URGENT Field Safety Notice
ProxiDiagnost N90 1.1 and ProxiDiagnost Upgrade

Software Defects causing imaging issues during Radiography and Fluoroscopy examination

05-December-2023

Figure 2. Export only “not flagged” images

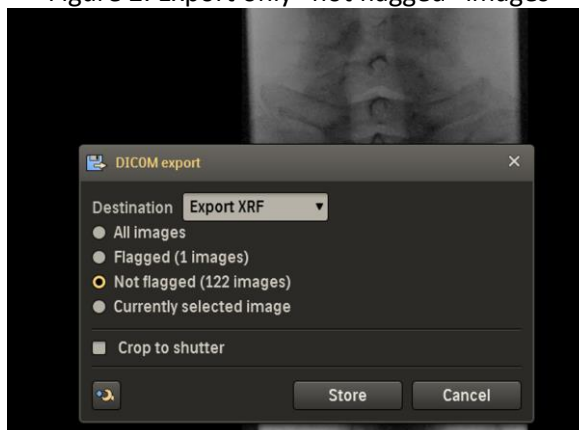
Issue 1: Mixed Images: Philips has identified that the Radio Fluoroscopy (RF) viewer may also display a previous patient's radiography (RAD) images when starting the next patient scan while the previous patient image export is still processing. If the issue occurs, there is a potential for incorrect patient data to be displayed in the image.

- To avoid previous patient data from being represented as current patient data, ensure all images have been exported from the previous RAD exam before starting a new examination.
- Correct images will be square shape and wrong images can be recognized by a different patient anatomy and rectangular shape. If you identify a wrong image, flag the incorrect images and only export “not flagged” images for the current examination to PACS (See figure 2 below).

A Field Service Engineer (FSE) will contact you to schedule a time to visit your site and install the software upgrade to resolve the issues (Reference FCO70600110). Philips plans to start implementing the solution in Q2 2024.
